UNITED STATES  
DEPARTMENT OF THE INTERIOR  
BUREAU OF LAND MANAGEMENT

FORM APPROVED  
OMB NO. 1004-0135  
Expires: July 31, 2010**SUNDRY NOTICES AND REPORTS ON WELLS**  
*Do not use this form for proposals to drill or to re-enter an abandoned well. Use form 3160-3 (APD) for such proposals.***SUBMIT IN TRIPLICATE - Other instructions on reverse side.**

**Burton 6 Fed #1**  
**Return well to Production**

## Conditions of Approval

# DRILLING PROGNOSIS Cimarex Energy Company

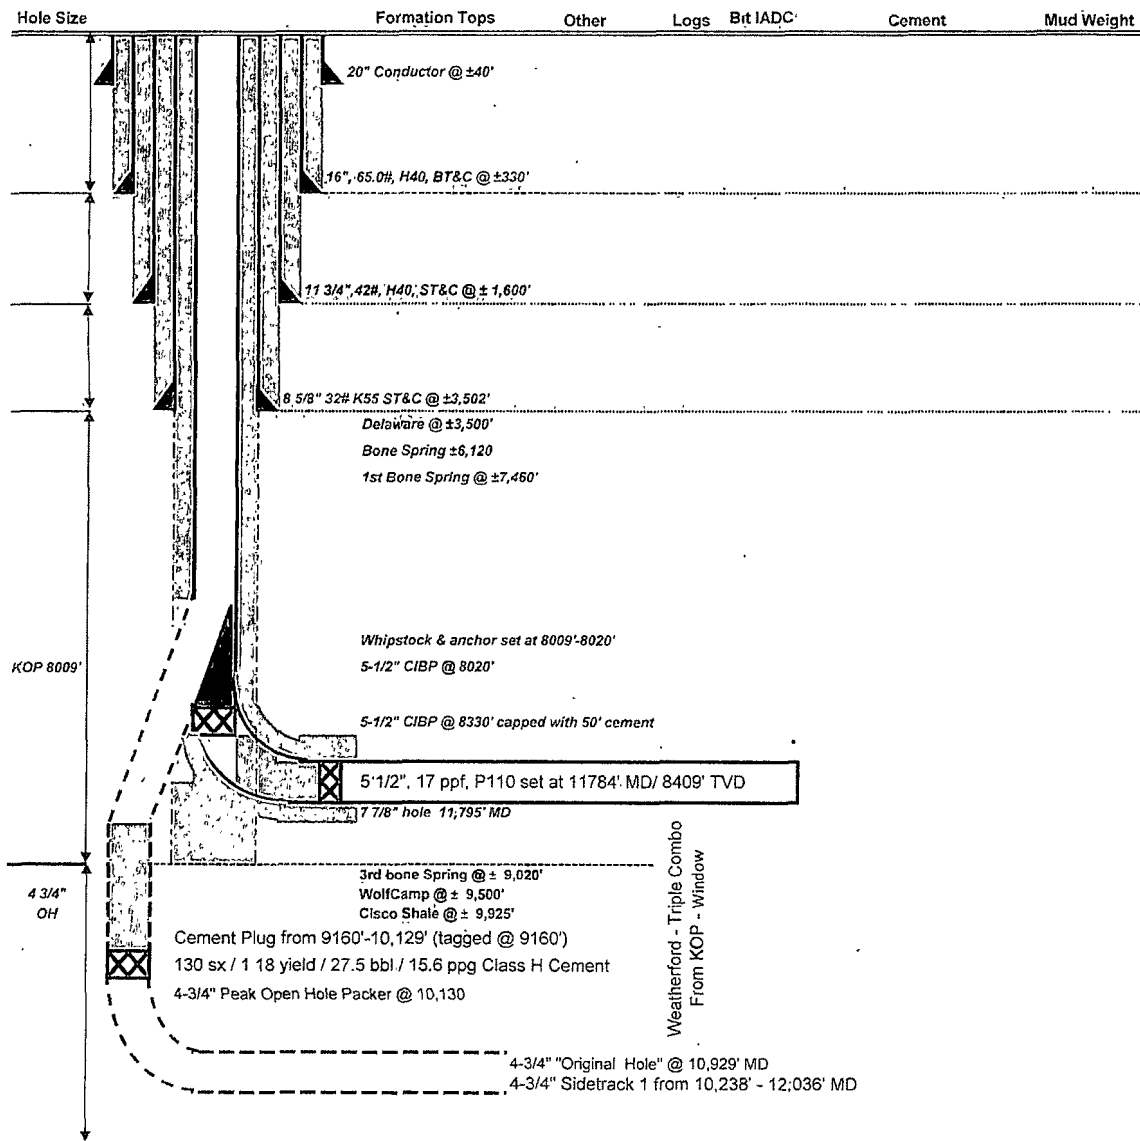
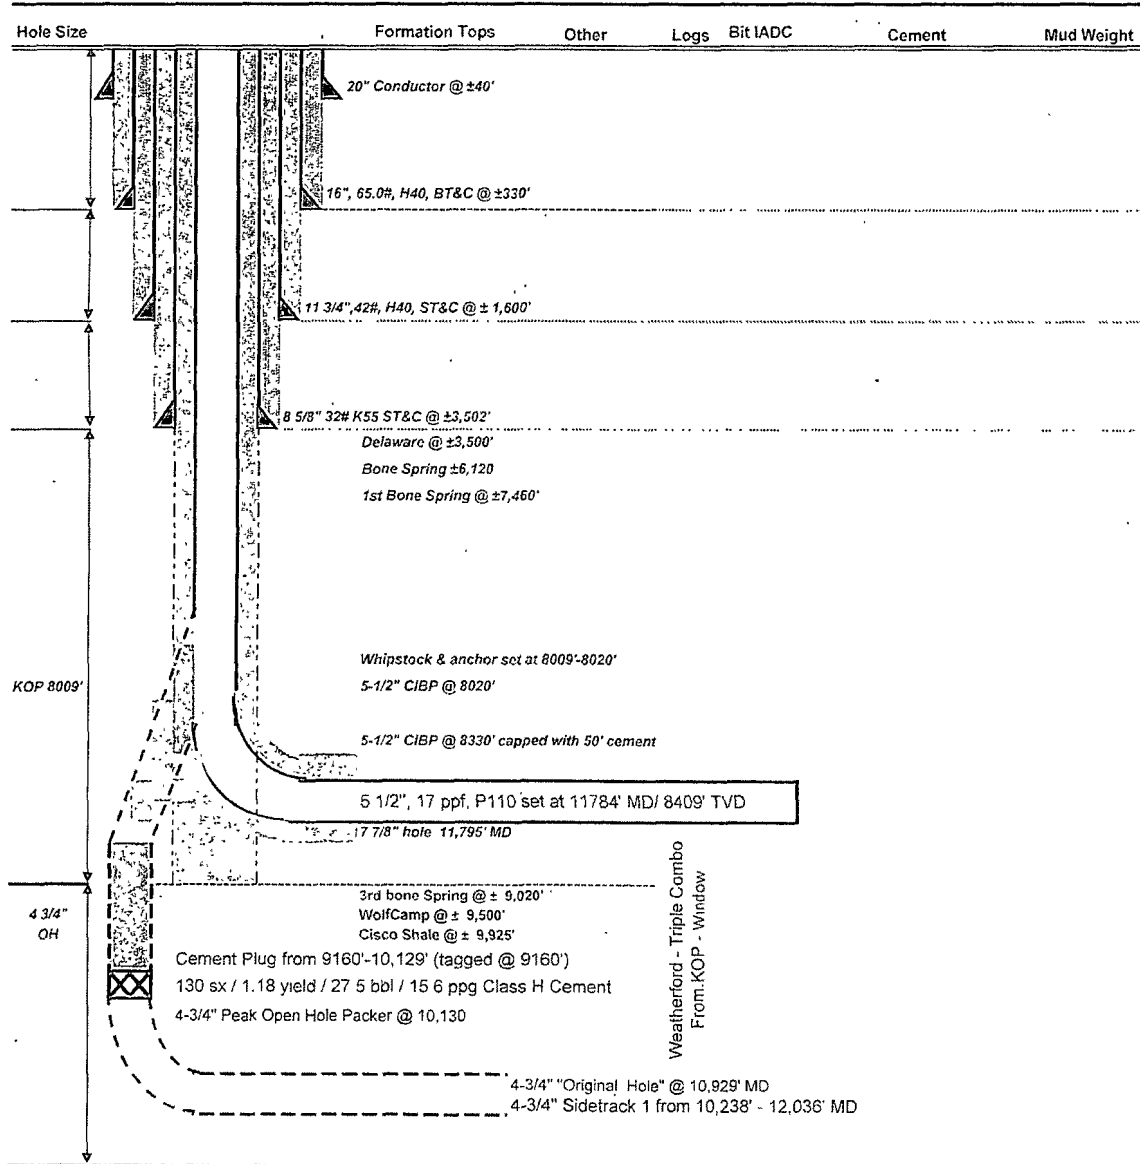
Please see attached procedure, before and after wellbore diagrams for your review and approval.

9. **Modify Step 4 of operator's procedure: RIH and set CICR at 7950'. Pump sufficient Class H cement mixed 15.6lb/gal, 1.18ft<sup>3</sup>/sx, and 5.2g/sx to squeeze cement outside of the window from 8007-8017'.**

10. **Addition to Step 5 – pressure test to be witnessed by a BLM PET and charted.**
11. File a **subsequent sundry** Form 3160-5 within 30 days of the plug back describing the Cisco abandonment. Include an updated wellbore diagram.
